PLANNING COMMISSION MEETING

LOCATION: TOWNSHIP ANNEX, 7527 HIGHLAND ROAD, WHITE LAKE, MI 48383
THURSDAY, SEPTEMBER 05, 2024 – 6:30 PM

**WHITE LAKE TOWNSHIP
PLANNING COMMISSION
AUGUST 15, 2024**

DESIGNED BY:	ST
DRAWN BY:	DH
CHECKED BY:	
SCALE:	1" = 50'
JOB NO:	22-029-1
DATE:	05/30/24
SHEET NO.	10

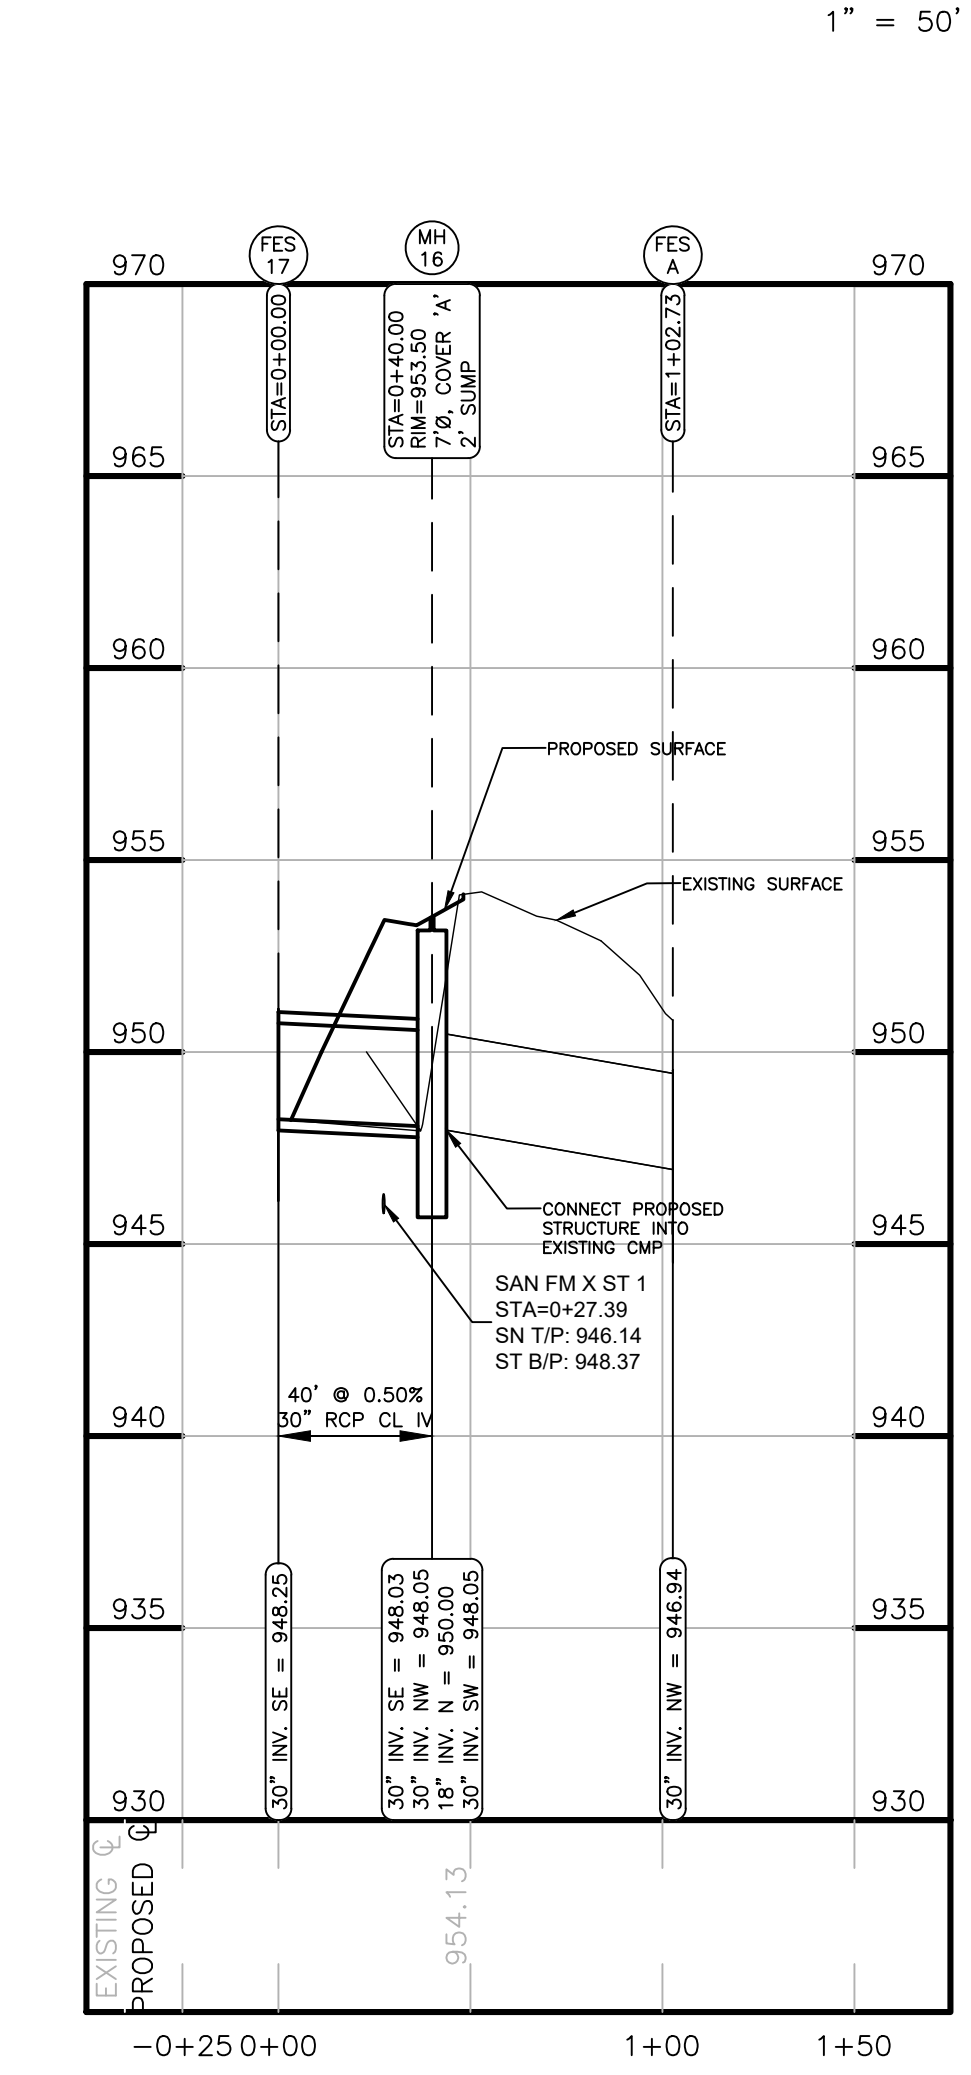
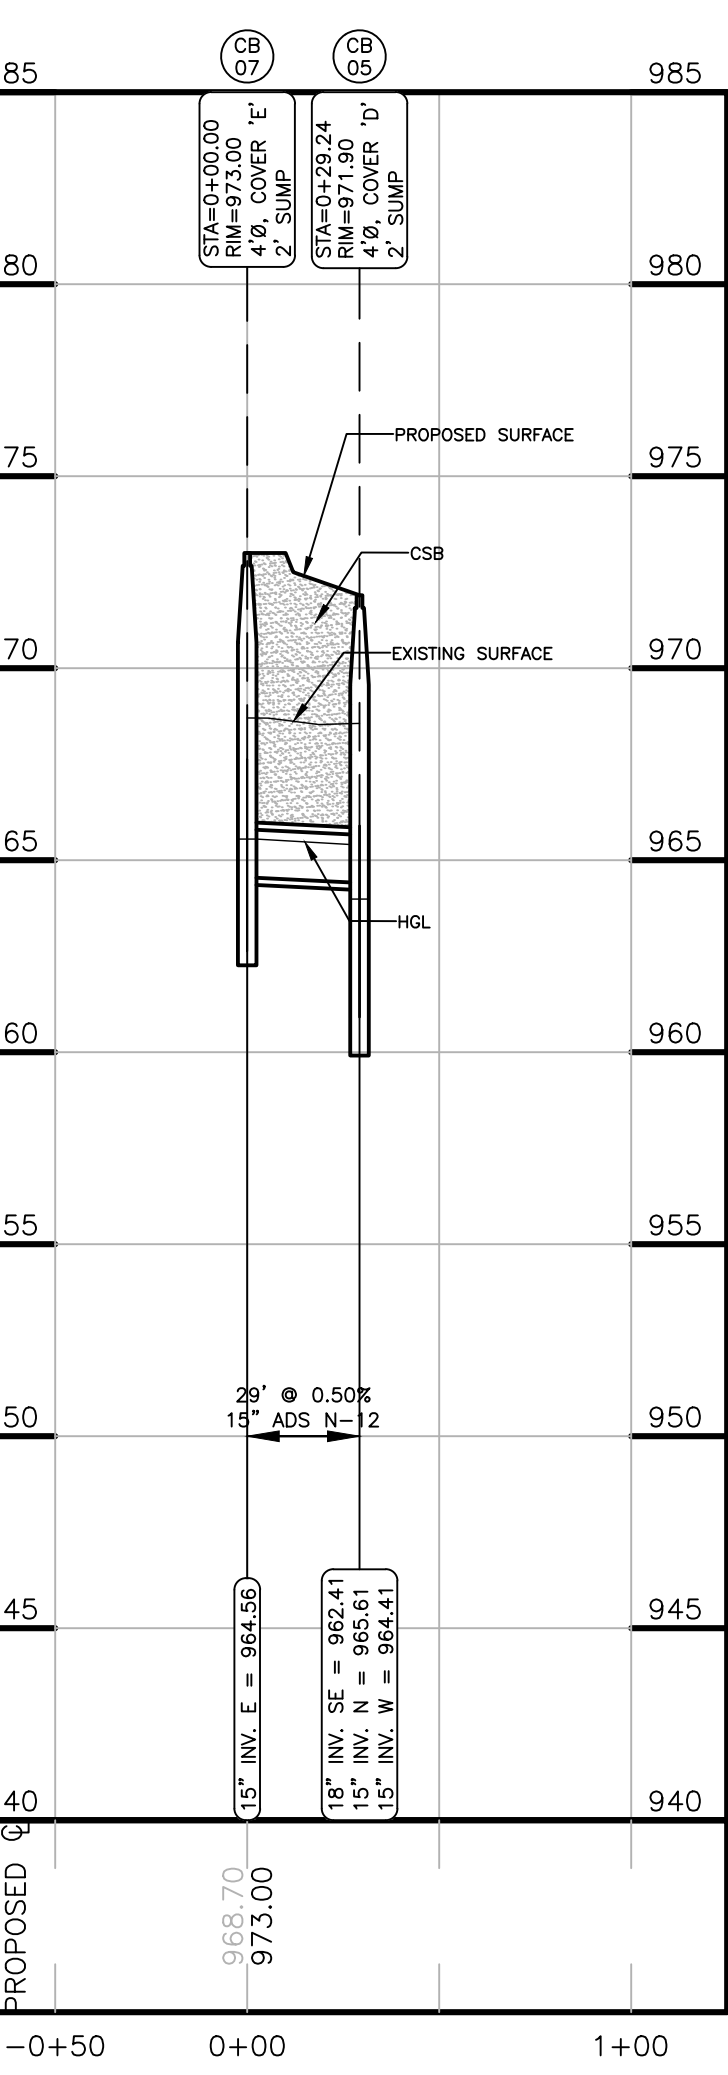
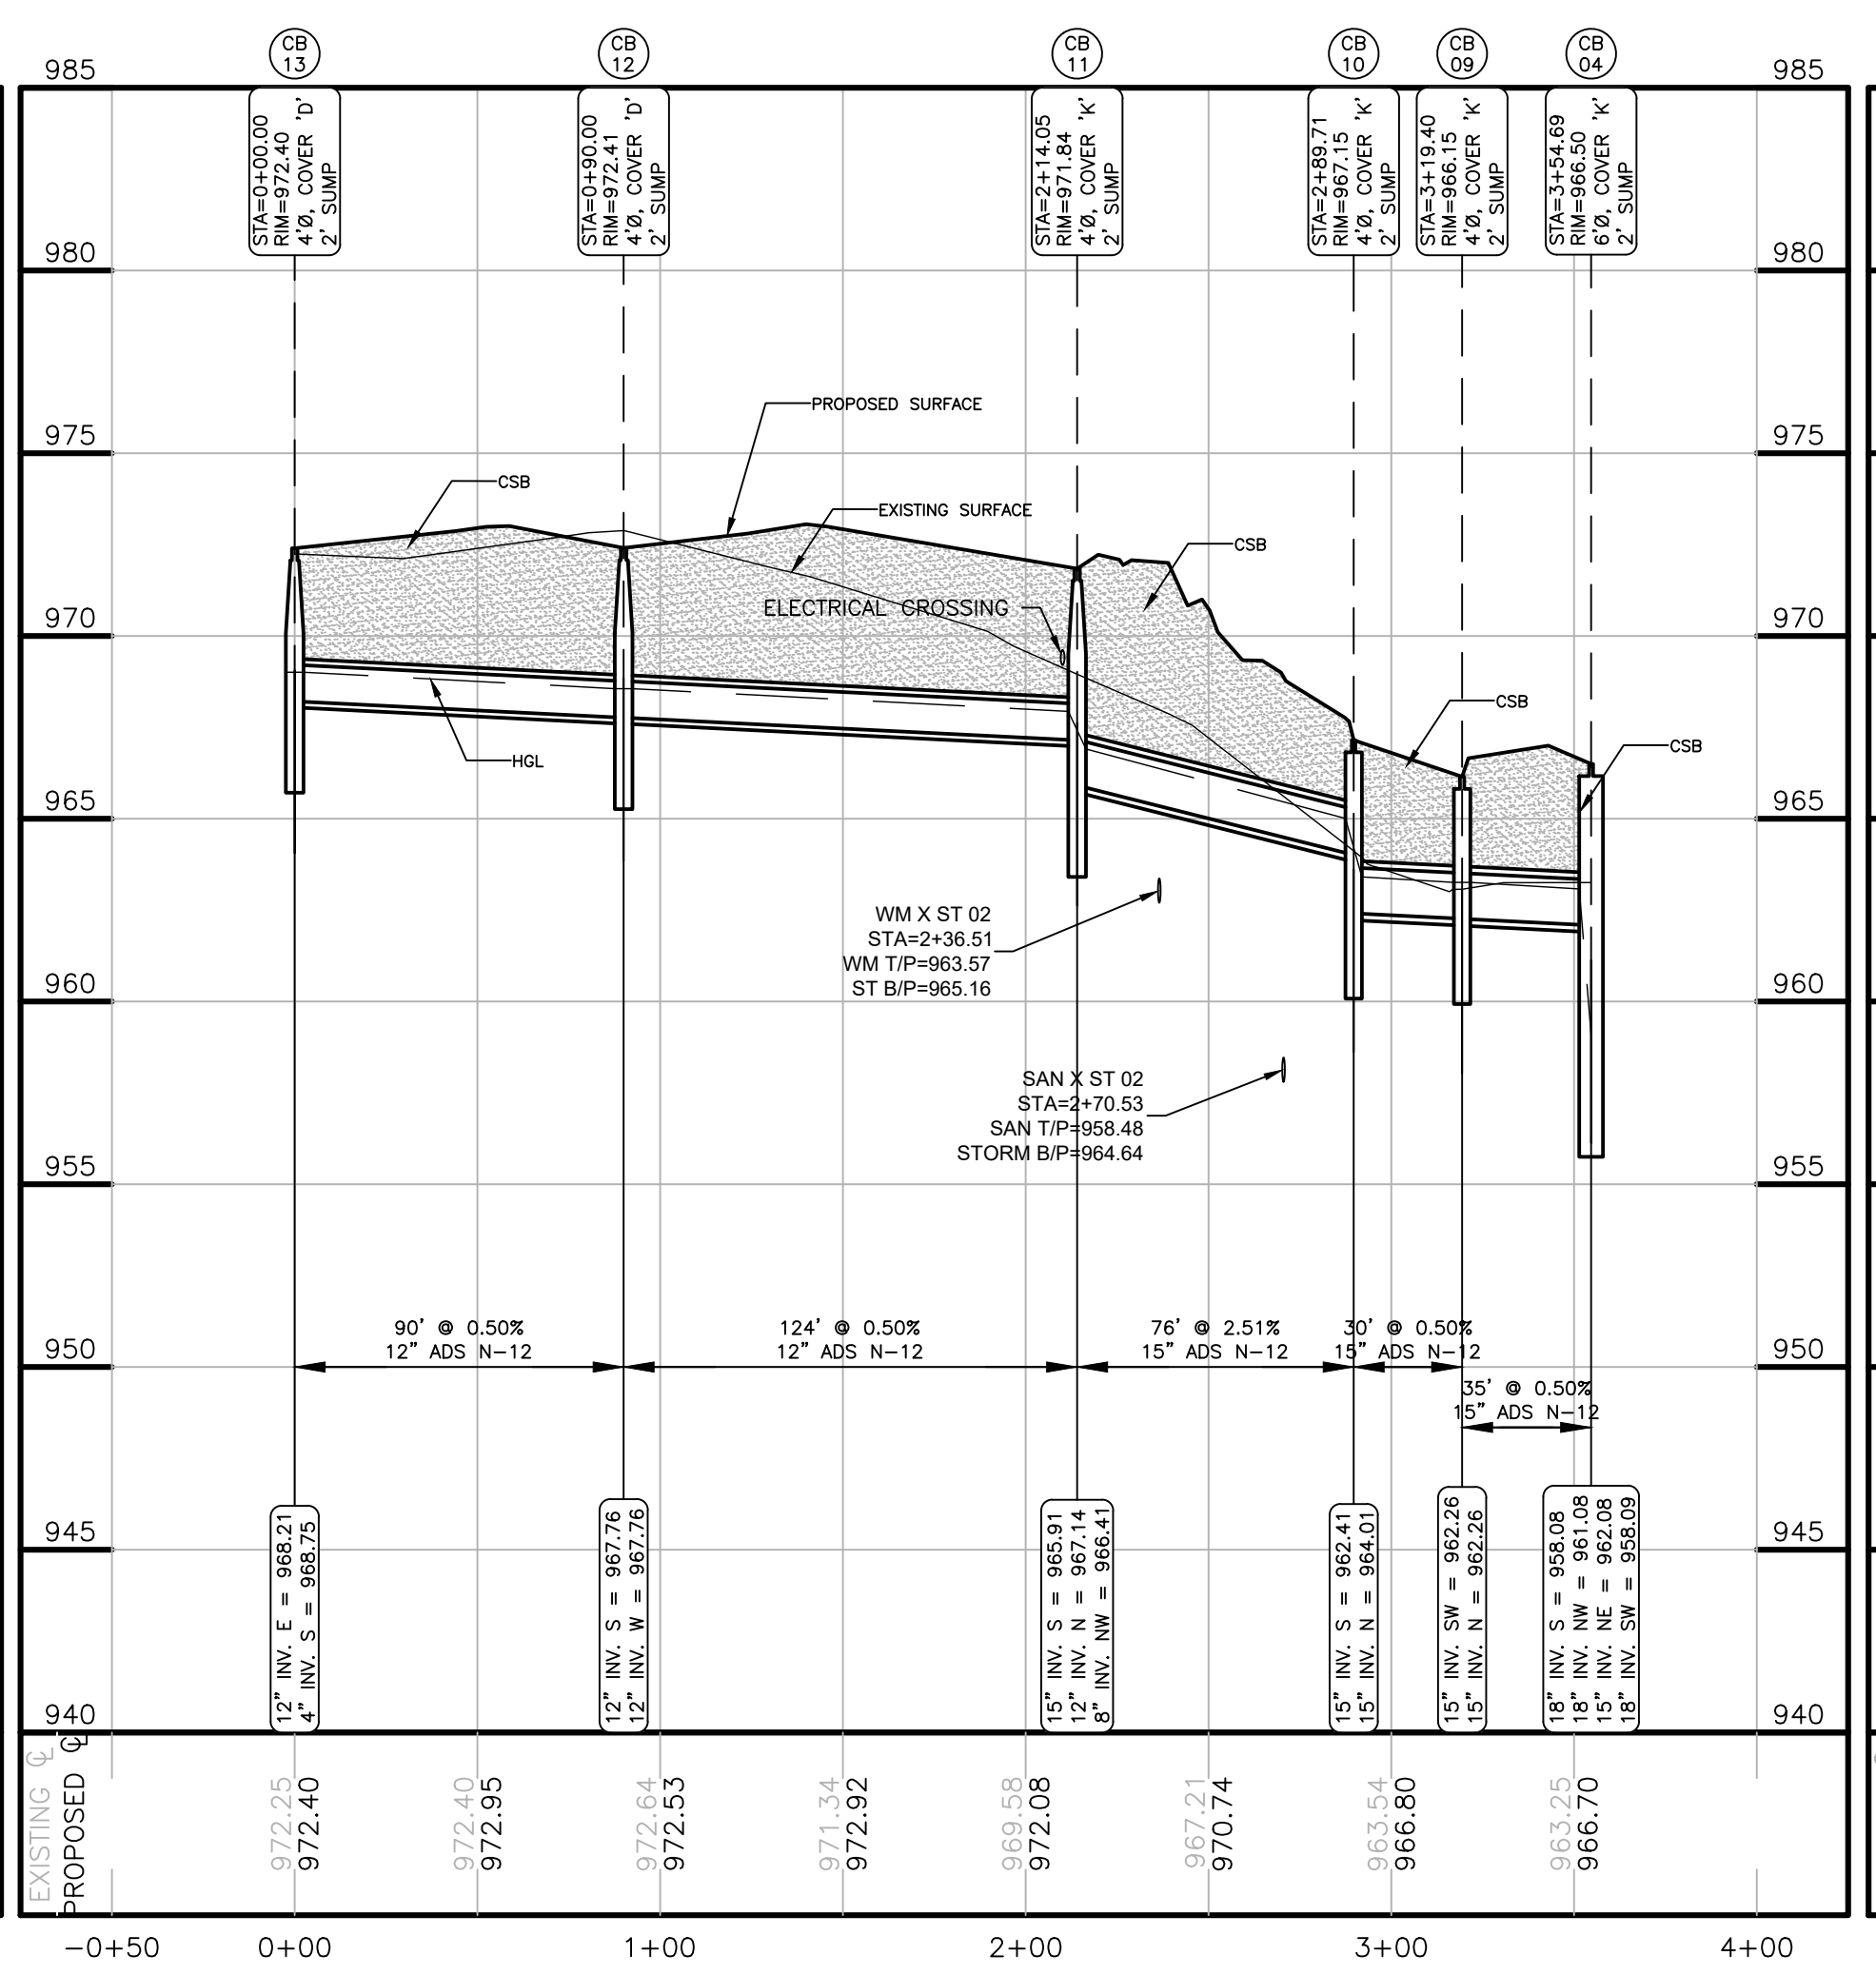
16. *Sheet 10 -Utility plan inset- Move FES A label for readability on plan.* **Comment addressed. Label has been moved.**
17. *Sheet 10- CB07- Rim elevation is incorrect. Please match that shown on grading plan and storm sewer pipe sizing calculations. That rim elevation on the grading plan and storm calculations appears to be the correct one.* **Comment addressed. Rim elevation has been corrected.**

18. *Sheet 10-CB07-CB06-Provide/show CSB near CB07 on the profile (in the area where 'Existing Surface' arrow is shown). CSB is required within the influence of pavement. Comment addressed. CSB has now been shown in this area.*

19. *Sheet 10- Label CB06 additionally as stormwater pretreatment unit. Comment addressed. Pretreatment unit has now been shown on profile.*
20. *Sheet 10- CB12-CB11- Show electric crossing. Comment addressed. Electric crossing is now shown.*

21. *Sheet 10-CB11-CB10- WM X ST 02-A minimum of 18" vertical separation is required between storm and watermain. Currently 12" of vertical separation is shown. In addition, label on crossing is incorrect and is labeled as SAN B/P. Please relabel to WM B/P. Comment addressed. 18" minimum vertical separation is now shown, and label has been corrected.*

22. *Sheet 10-FES 14-MH 14A- Please investigate whether it is possible is lessen the pipe slope to < or = 3.62% maximum pipe grade for this run of pipe. It is understood that due to steep grade constraints on the site that this may not be feasible. In addition, please review the 8.00% grades on pipe runs FES18-MH16-MH19 for the same. Comment addressed. Severe pipe run slopes have been reduced.*

23. *Sheet 10- OCS 2- A minimum of 3' sump is required for this structure. Comment addressed. A 3' sump has been provided.*
24. *Sheet 10-Basin Out – OCS2- Pipe slope calculates to 0.50% and not 0.40% based on provided inverts. Please revise. Comment addressed. Pipe slope has been revised.*

32. Sheet 10-CB04 to MPS 3 IN and MPS 3 OUT to BASIN IN- Shows ADS N-12 as pipe material while Sheet 5 shows ADS SCH 40 for these two runs. Please revise for consistency between sheets.
